**Bell Lane Application
15/01376/OUT**

26th October 2016

LAND ADJACENT TO BELL LANE, POULTON

FILE NOTE DEALING WITH FLOODING AND DRAINAGE

enzygo environmental consultants		CLIENT MRS Wigram
SCALE 1:800@A3	PROJECT REF SHF.1109.005	PROJECT Land off Bell Lane, Poulton
DRAWN MG	CHECKED MJ	DATE Sep 2016
TITLE Indicative Drainage Layout		PROJECT NO. SHF.1109.005-105-D-000-C

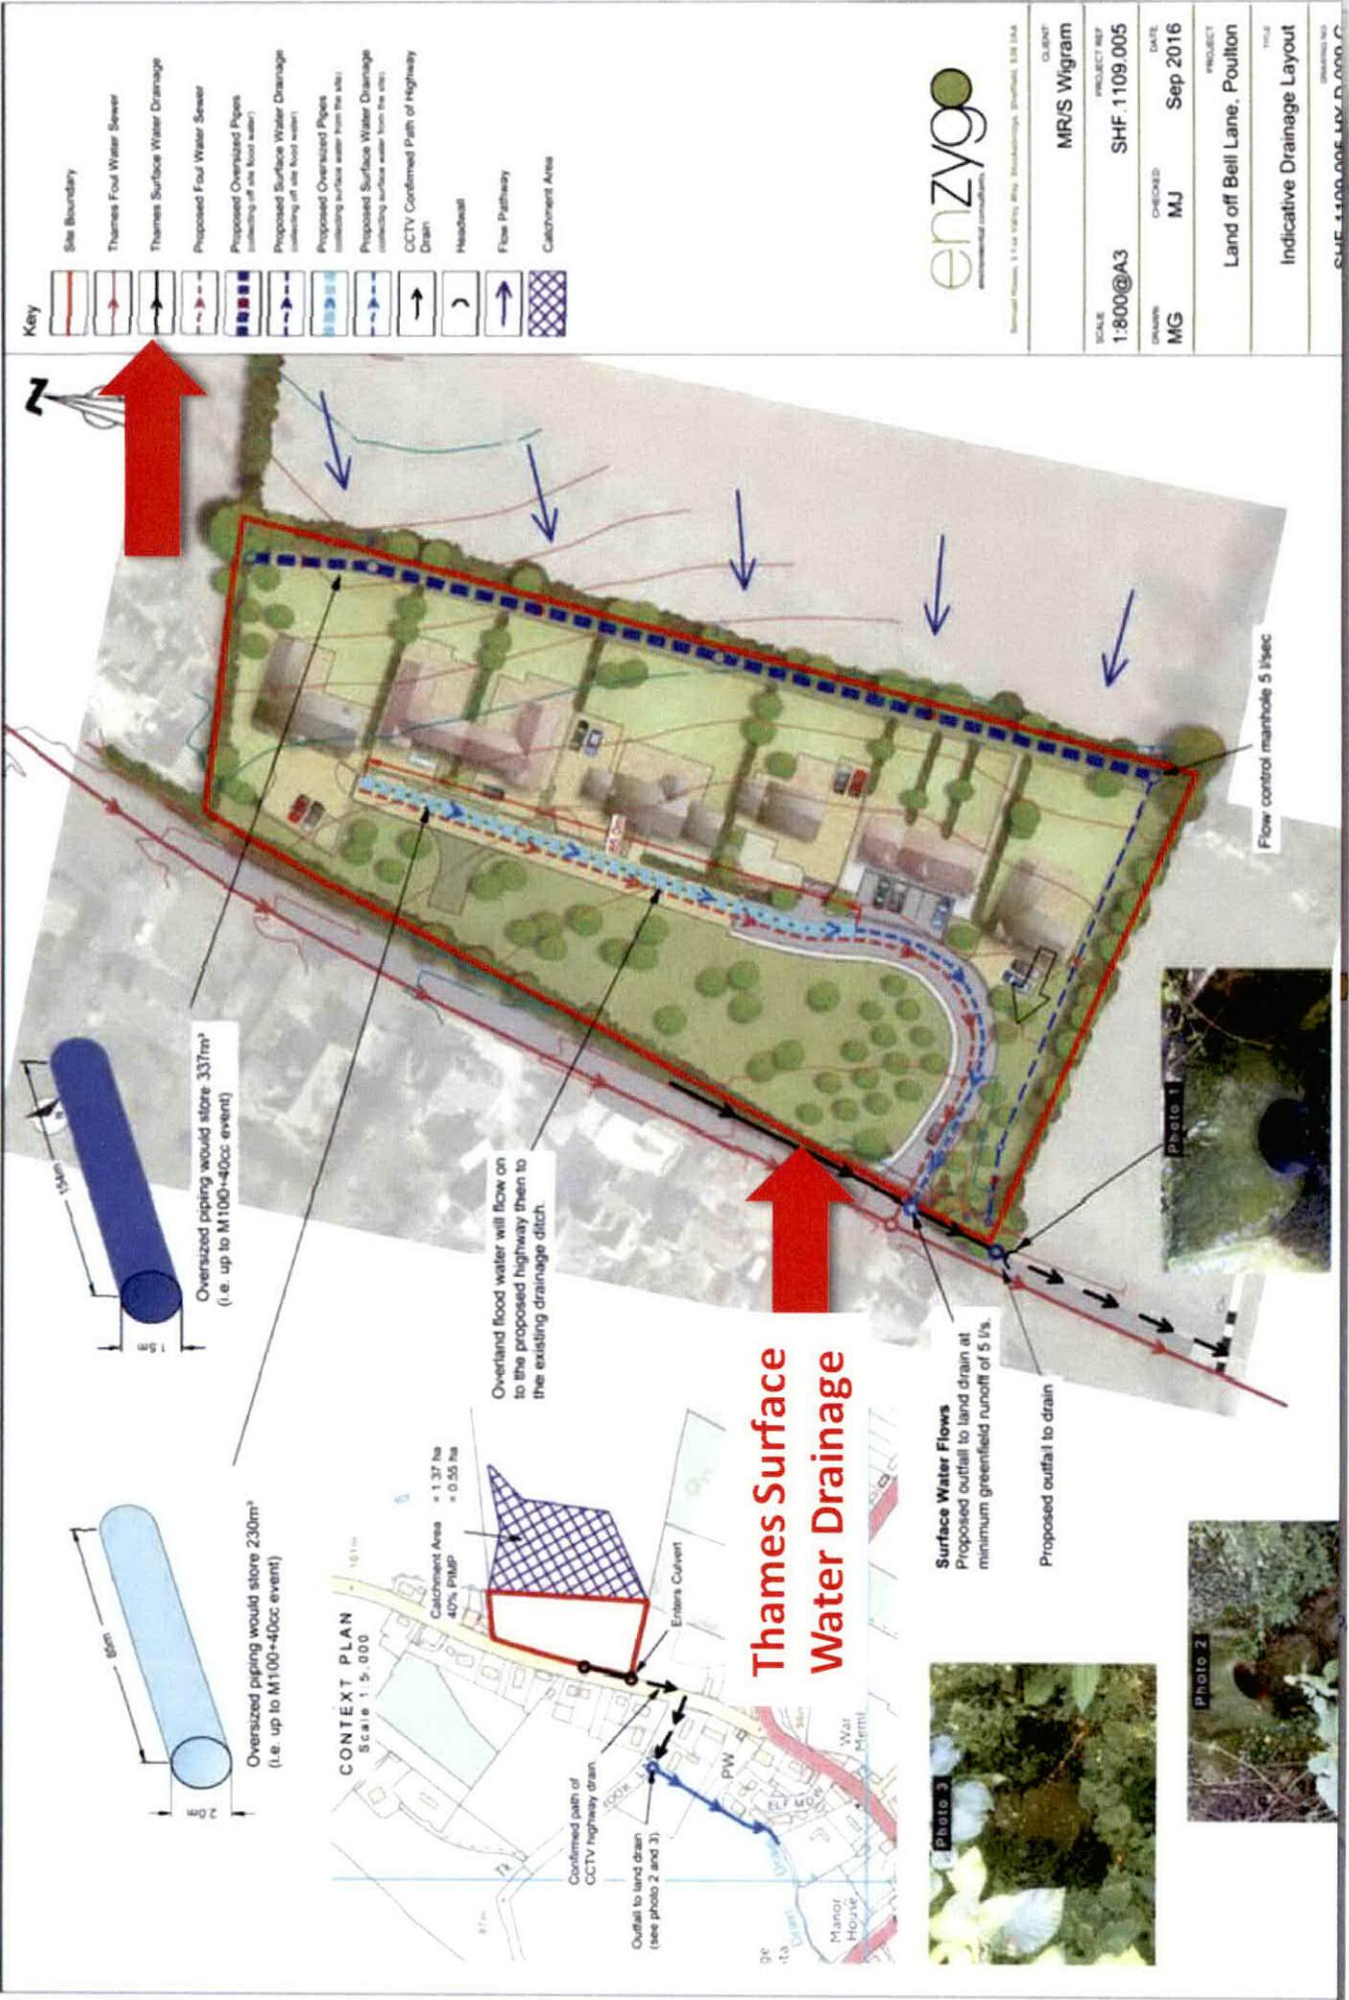
Flow diagram to identify catchment area has changed considerably, from over 29 to 1.37ha. Earlier submissions, estimating much larger catchment used a more detailed LiDAR map; Current submission indicates a much lower catchment area, using a less detailed map. The arrows appear to flow very differently in most recent mapping. Why? What has changed?

The latest drawing shows the catchment area missing some of the flow arrows that flow onto the site.

The flow arrows go in very different directions on the two maps – why? When nothing has changed?

Appendix 2 – Indicative Drainage Design

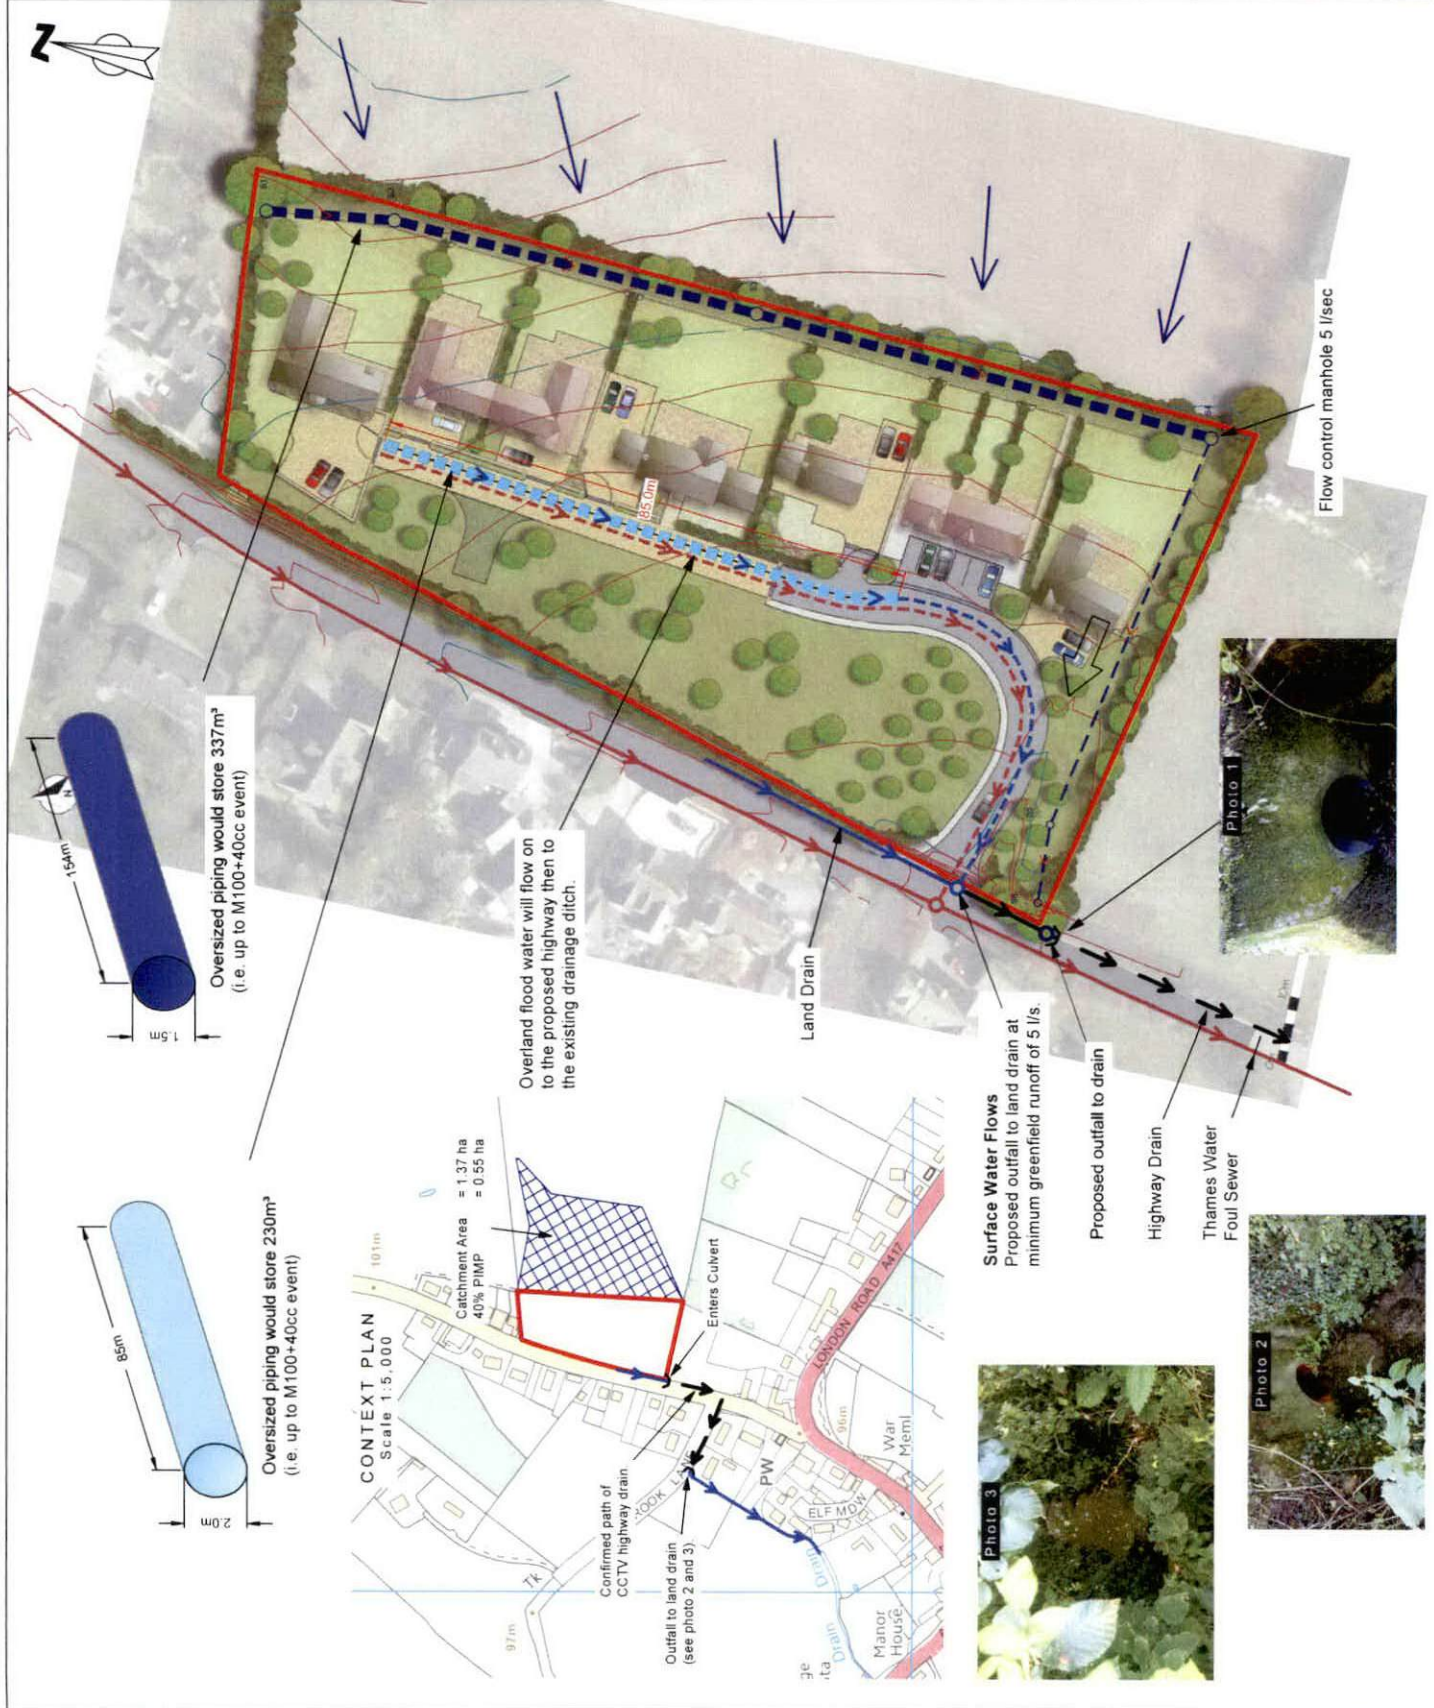
- 3.5. It is also noted that the volume shown for this pipe on the Indicative Drainage Layout does not tally with the pipe dimensions. It may be that the additional storage volume would be provided in the swale, however this should be confirmed.

- 3.6. The onsite drainage proposals utilise an oversized pipe with an outfall to the ditch adjacent to Bell Lane. It is unclear whether flows from driveways and private areas have been included in the impermeable areas used for sizing the oversized pipe. The Drainage File Note (dated September 2015) states that these areas should be constructed using permeable paving to encourage infiltration. The report also states that infiltration drainage is unlikely to be effective and so these areas should be included in the contributing areas for the onsite drainage system.

- 3.7. The oversized pipe has been designed with an outflow rate of 5 l/s. The photographs and modelling show that the area around the site entrance, where an outfall would be formed to the ditch, is affected by surface water flooding from offsite flows. It is therefore likely that during larger rainfall events the outfall from the site would become submerged and prevent flows from the onsite drainage system entering the ditch. A simulation of the effect of the outfall becoming submerged should be undertaken to assess the additional storage that would be required to mitigate the effect of this. Without this assessment it is likely that the onsite drainage system would be overwhelmed resulting in uncontrolled overland flows exiting the site onto Bell Lane.

Drawing dated Sept 2016

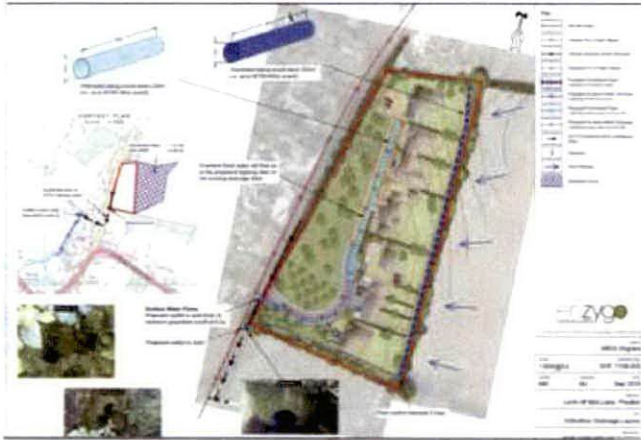
NOTE: 337m^3 is not correct anyway – supporting data shows 377m^3 .

THIS IS JUST ONE OF MANY EXAMPLES OF ERRORS – HOW CAN THERE BE ANY CONFIDENCE IN ANY OF THE CALCULATIONS?

Drawing dated Sept 2016

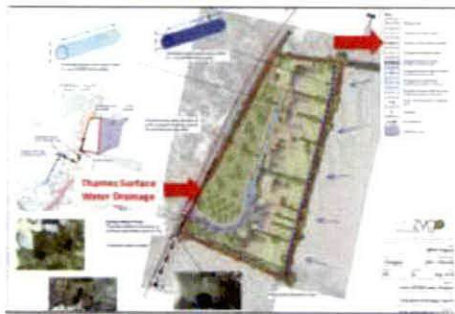
Shows a connection to 'Thames Surface Water Drainage'

There is no evidence provided that Thames Water own this surface water drain.
